**CITY OF WELLSBURG  
BROOKE COUNTY, WEST VIRGINIA**

**CONTRACT #1 MAIN ST., CHARLES ST., AND COMMERCE ST. WATERLINE  
REPLACEMENT PLAN**

**ADDENDUM #3**

**THRASHER PROJECT #101-010-1117**

**#19**  
**INTERCONNECTION DETAIL COMMERCE ST. AND 5th ST.**

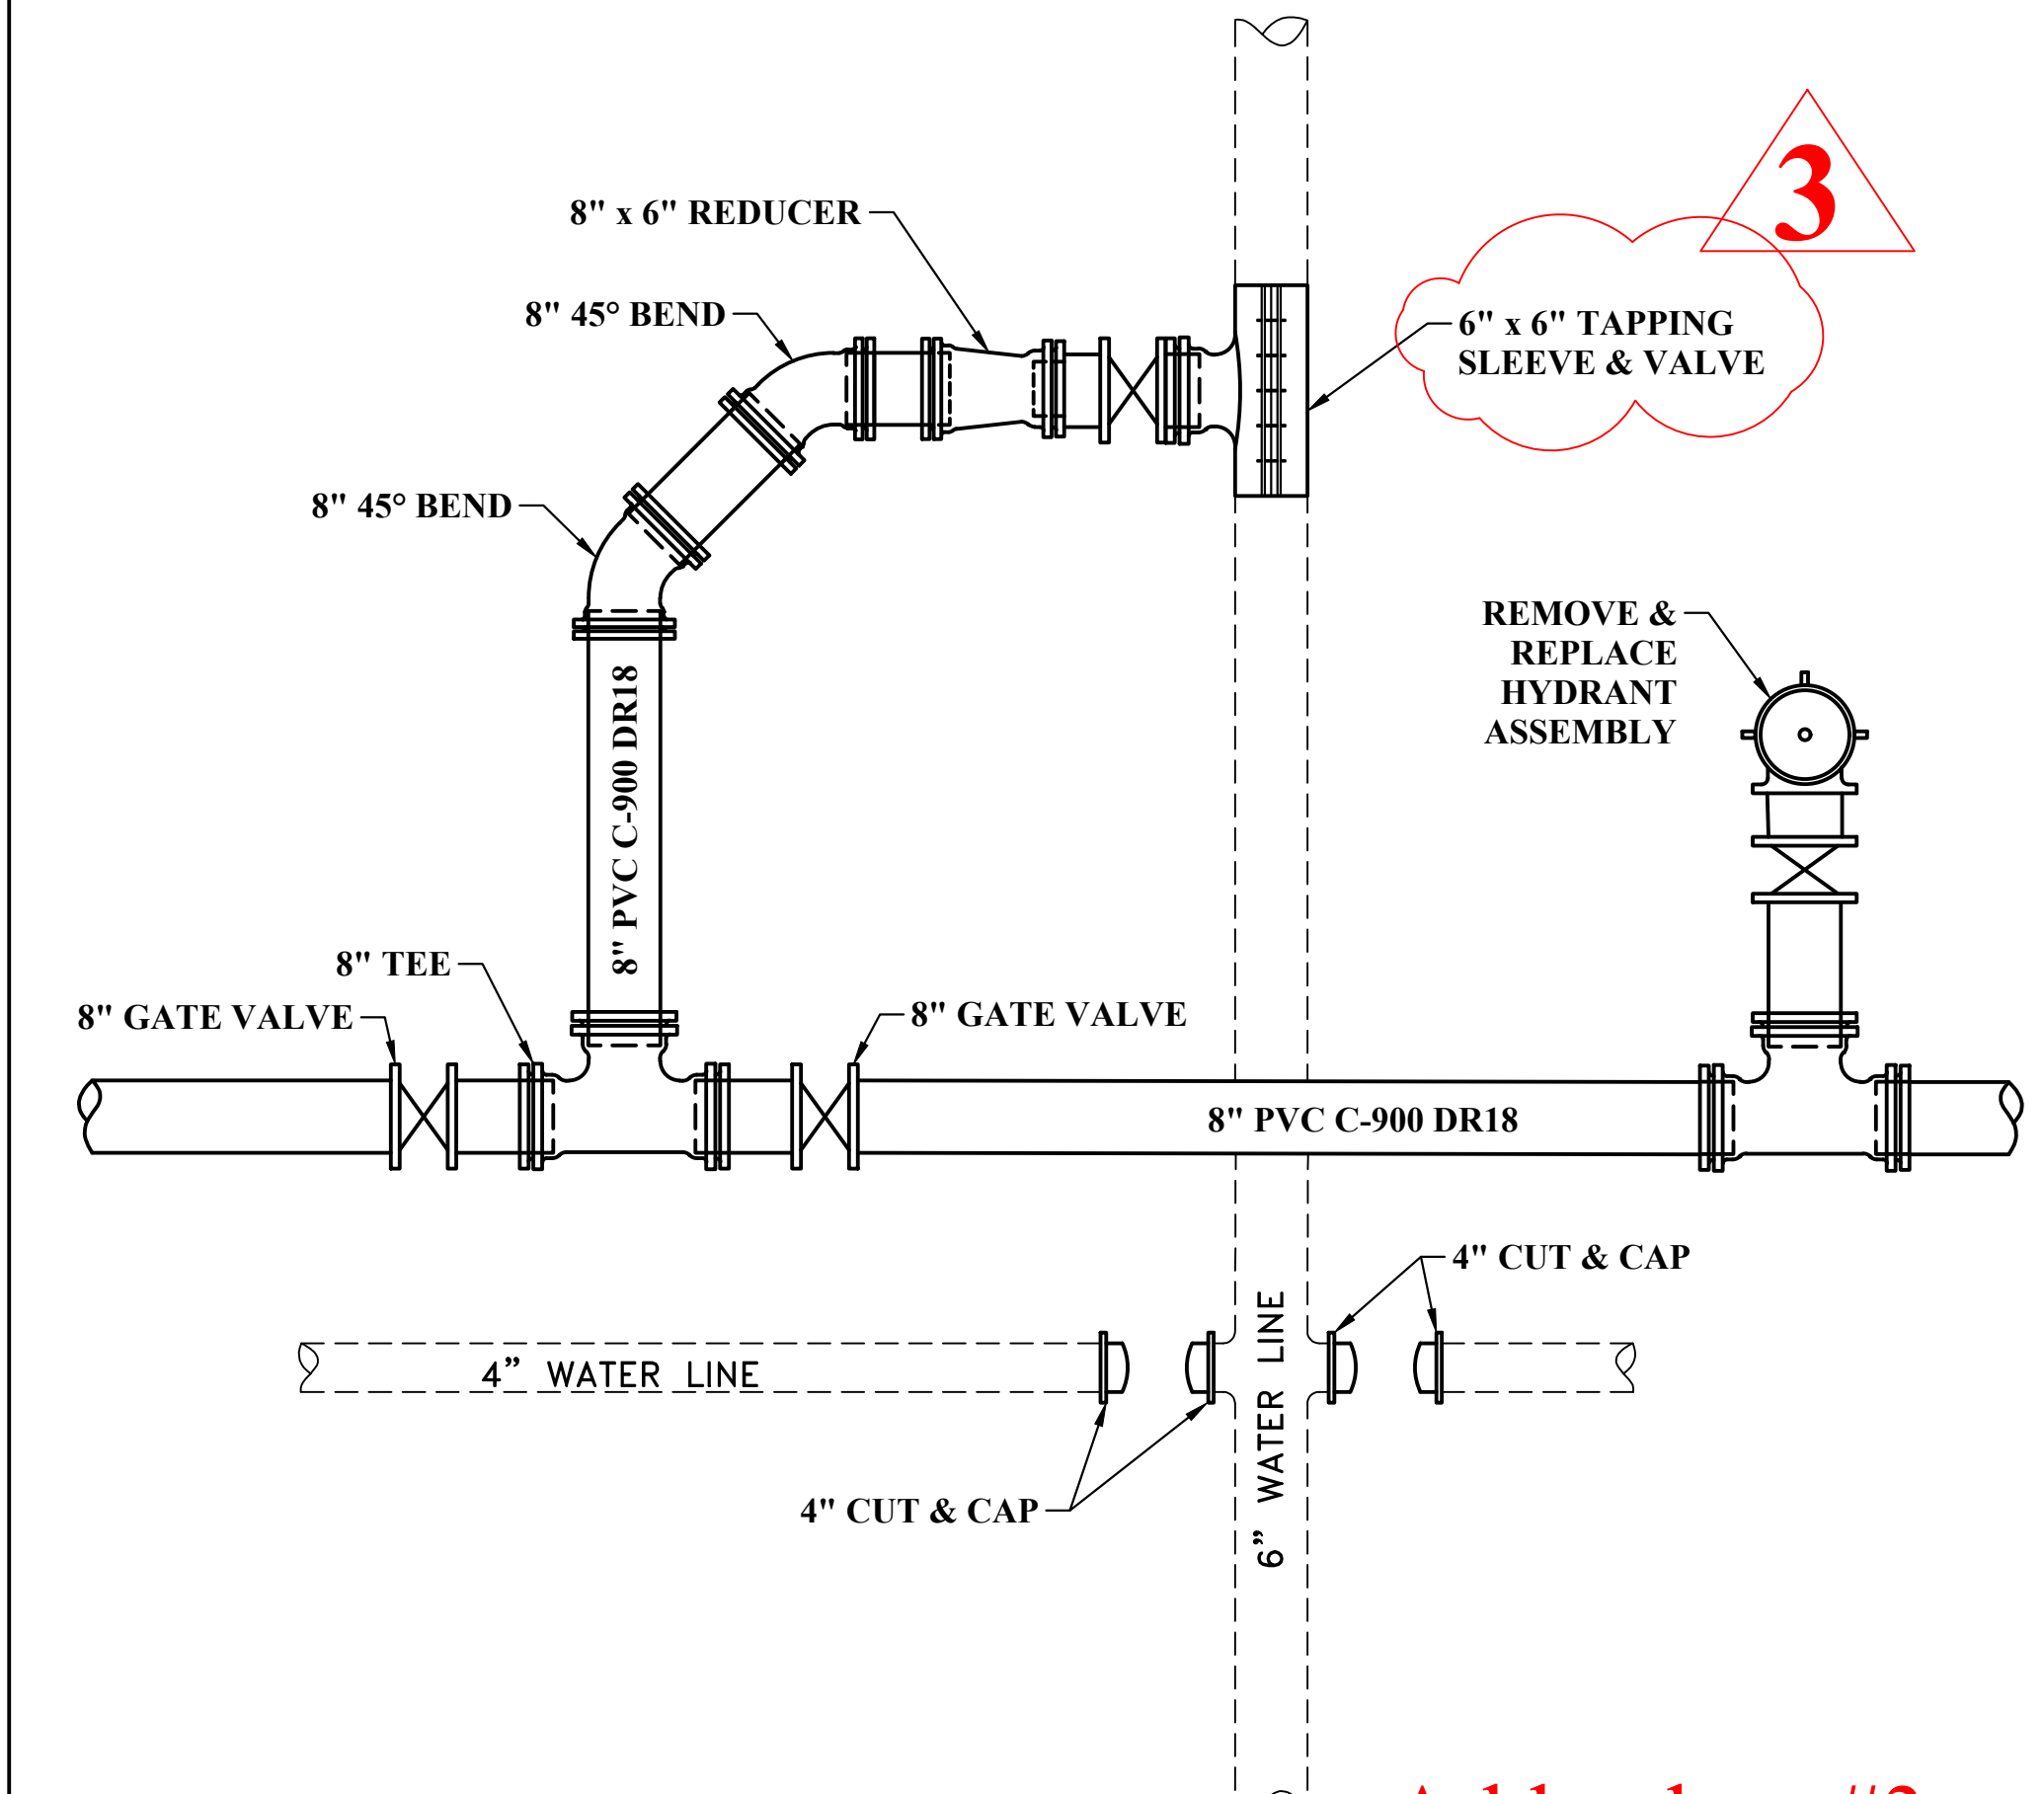
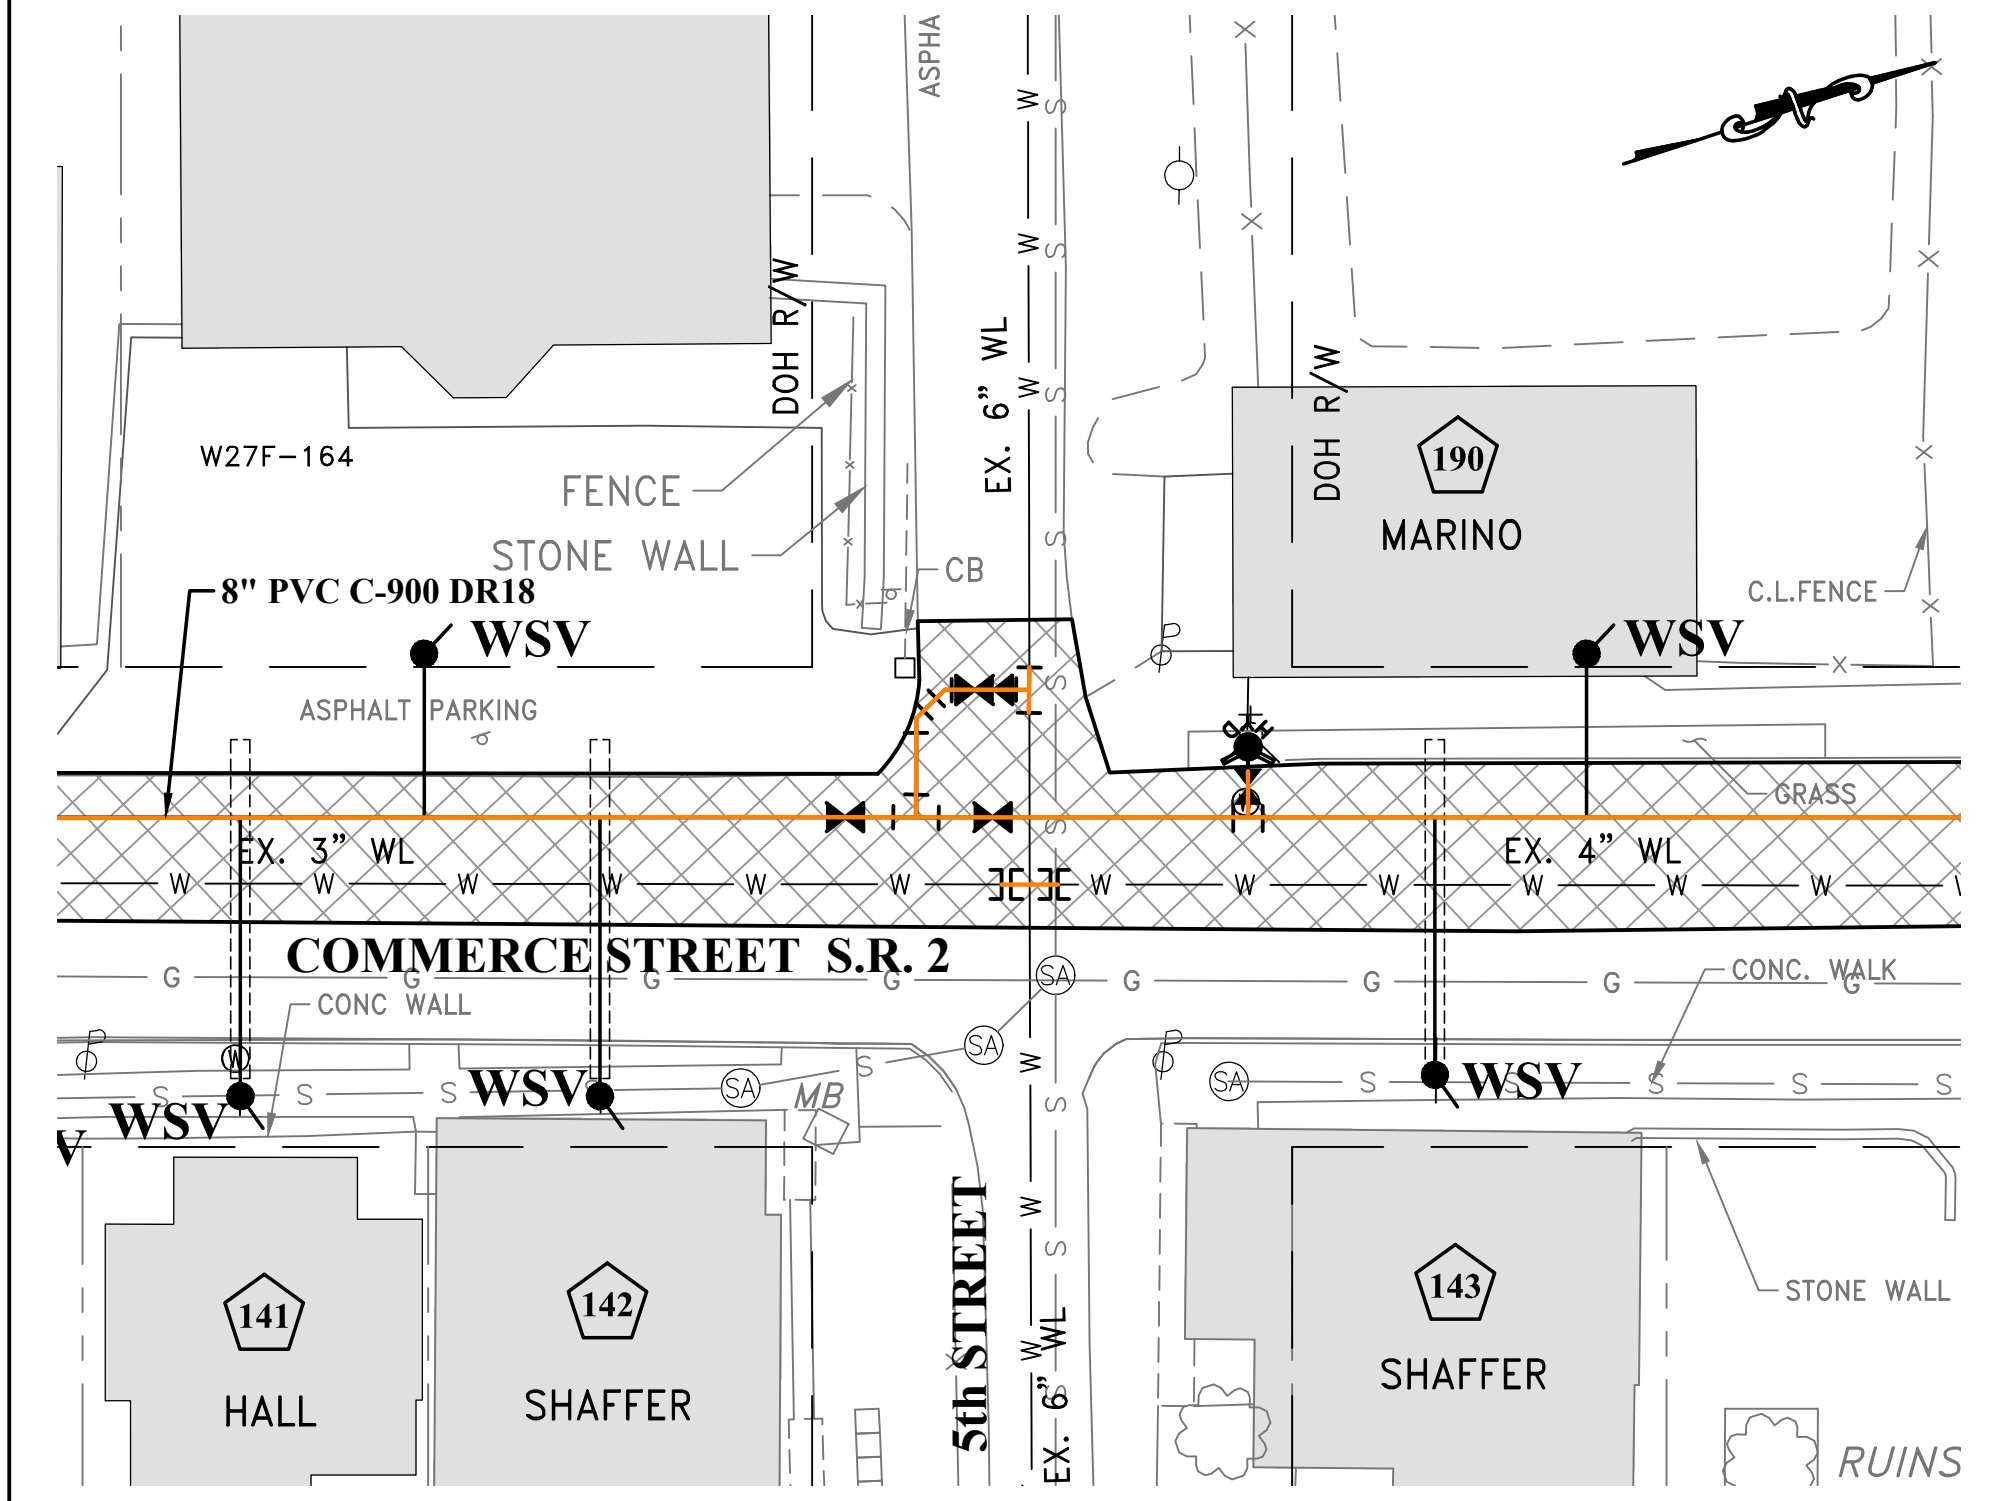
8. Detail #19 (6" x 8" tapping sleeve & valve on existing 6" line)? Please clarify

Detail #19 has been revised to show a 6" x 6" tapping sleeve & valve. See revised Sheet Number 15.

1	JLG	2/25/21	REVISED PIPE DIAMETERS FOR DETAIL 18 (ADDENDUM 2)
2	JLG	3/17/21	REVISED DETAIL #19 FROM 6"X8" TO 6"X6" (ADDENDUM 3)
NO.	BY	DATE	DESCRIPTION
